**TOWN OF BROOKLYN
PLANNING AND ZONING COMMISSION
Regular Meeting Agenda
Tuesday, August 18, 2020
6:30 p.m.**

**TOWN OF BROOKLYN
PLANNING AND ZONING COMMISSION
Special Meeting
Wednesday, July 8, 2020
Clifford B. Green Meeting Center
69 South Main Street
6:30 p.m.**

DATE: 6/2/2020 DRAWN: DJH
 SCALE: 1" = 40' DESIGN: DJH
 SHEET: 4 OF 7 CHK BY: ---
 DWG. No: HF 310 JOB No: 173055

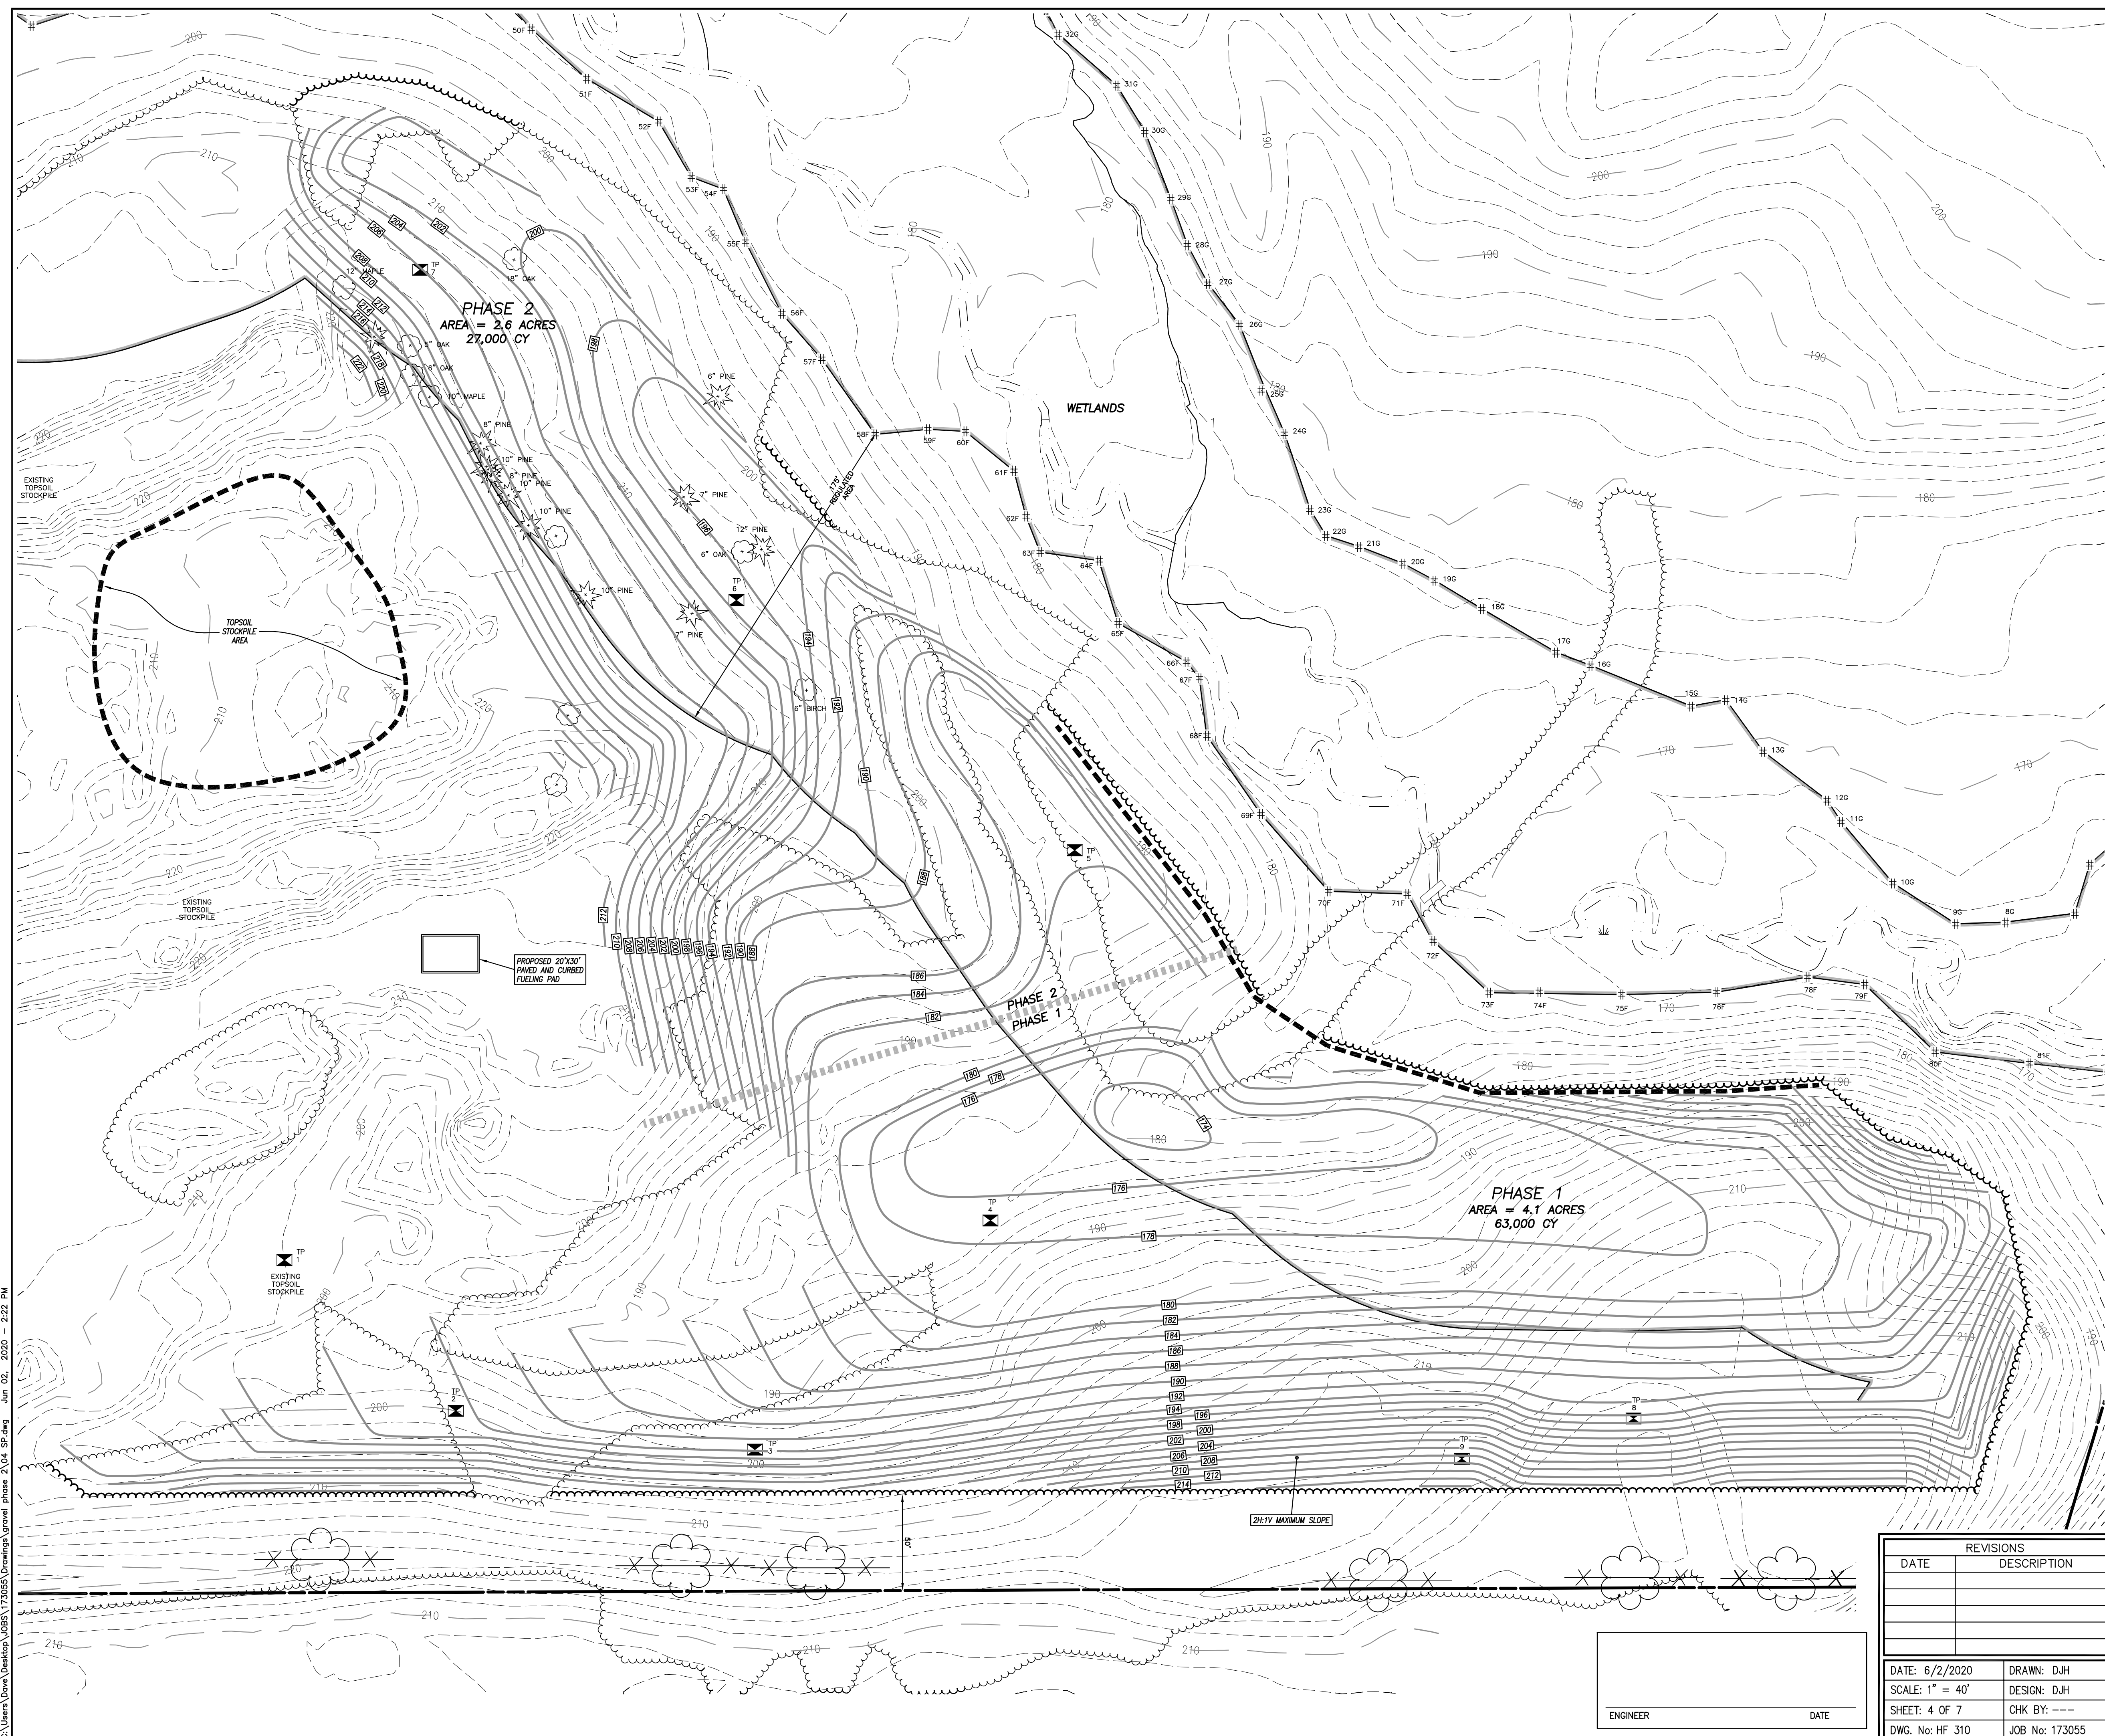
4. There is no estimated time of completion of the proposed gravel removal operation in the "Excavation Notes" on Sheet 5 of 7.
5. Noise and dust from heavy truck traffic may cause an issue with residents living along River Walk Drive and its connected side roads.

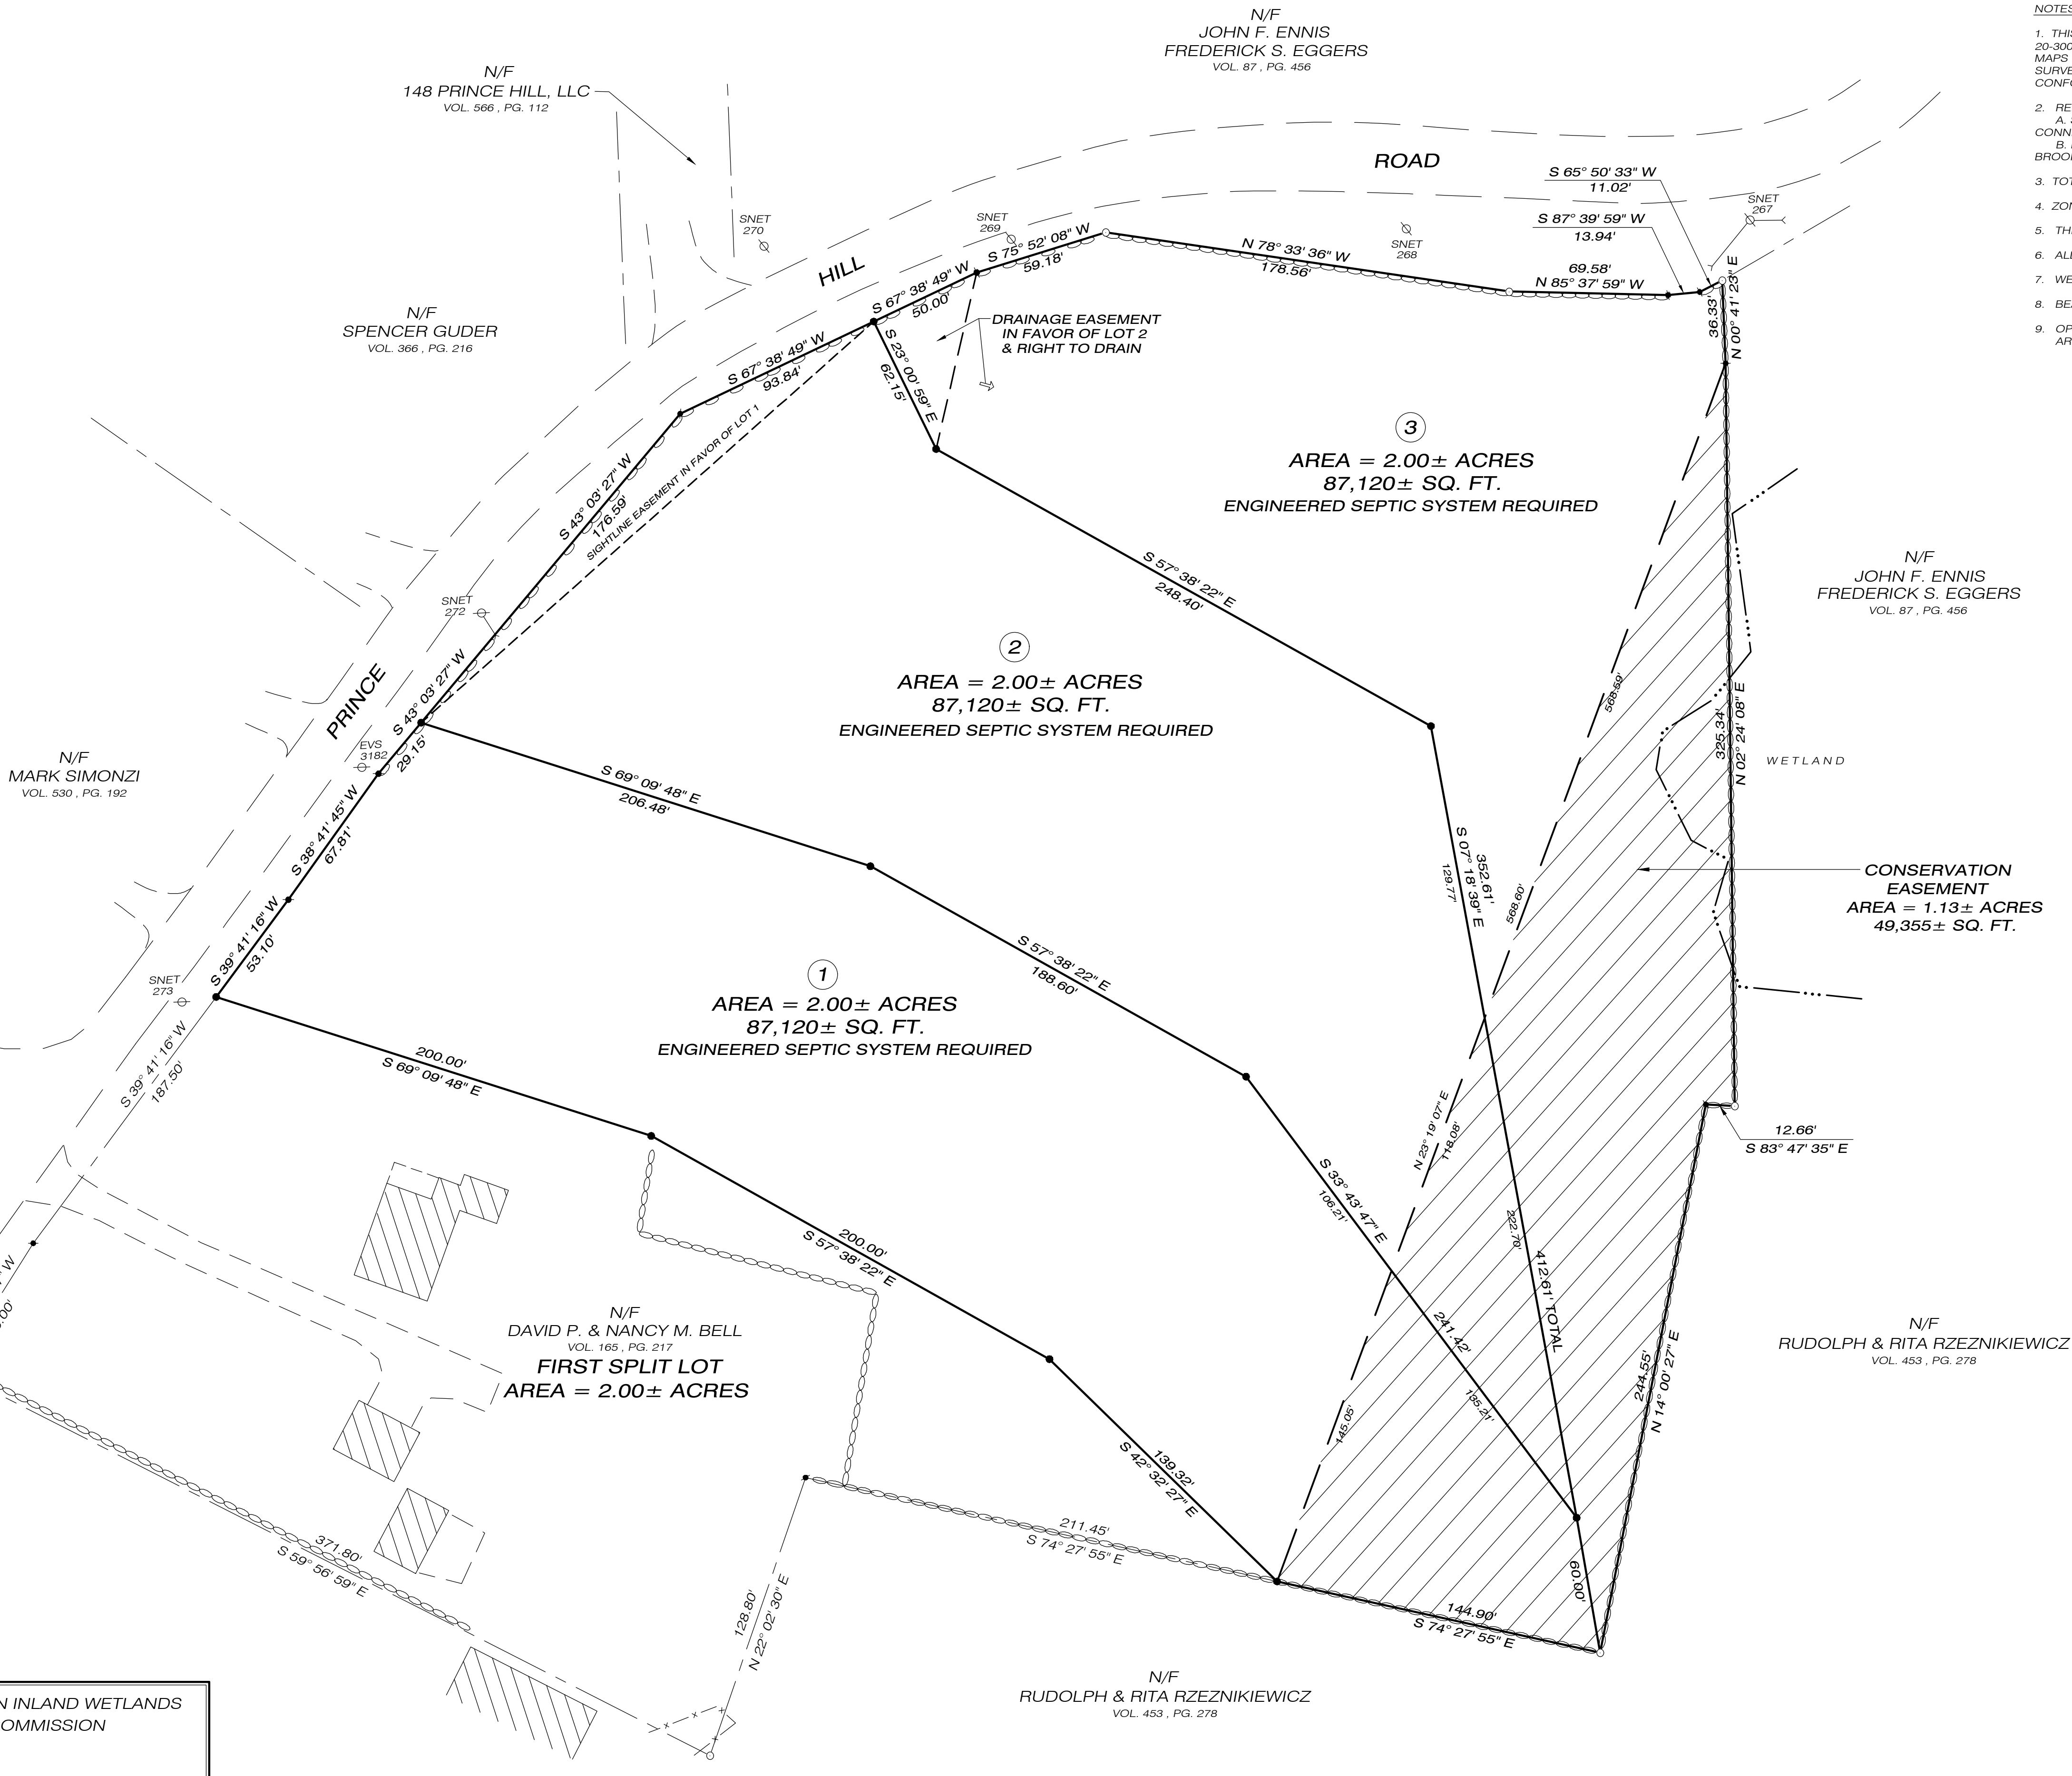
1. Below the test hole data listing, there is a note that states "*Additional percolation tests at depths above restrictive later to be performed on Lots 1 and 3 at the time of lot development.*" Why is this caveat here and is there a potential negative impact on building a house on this lot? Please explain.

CURTAIN DRAIN - LOT 3
NOT TO SCALE

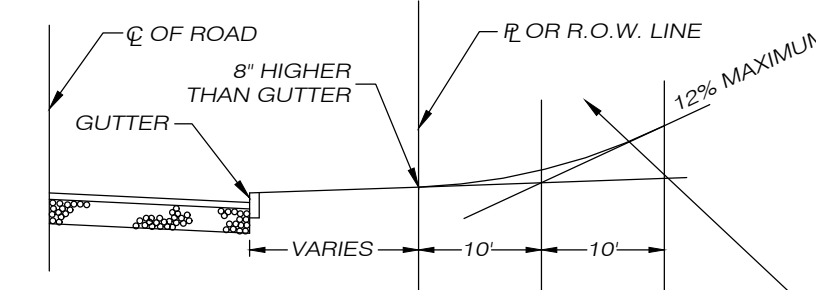
1. In the "Curtain Drain – Lot 3" detail, it is recommended that a detectable warning tape be placed over the PVC pipe to allow tracing once it is buried.
2. Again, in the "Curtain Drain – Lot 3" detail, how are the perforations to be oriented – up or down? Also, the current Connecticut Department of Transportation publication is Form 818, thus the note should be corrected.
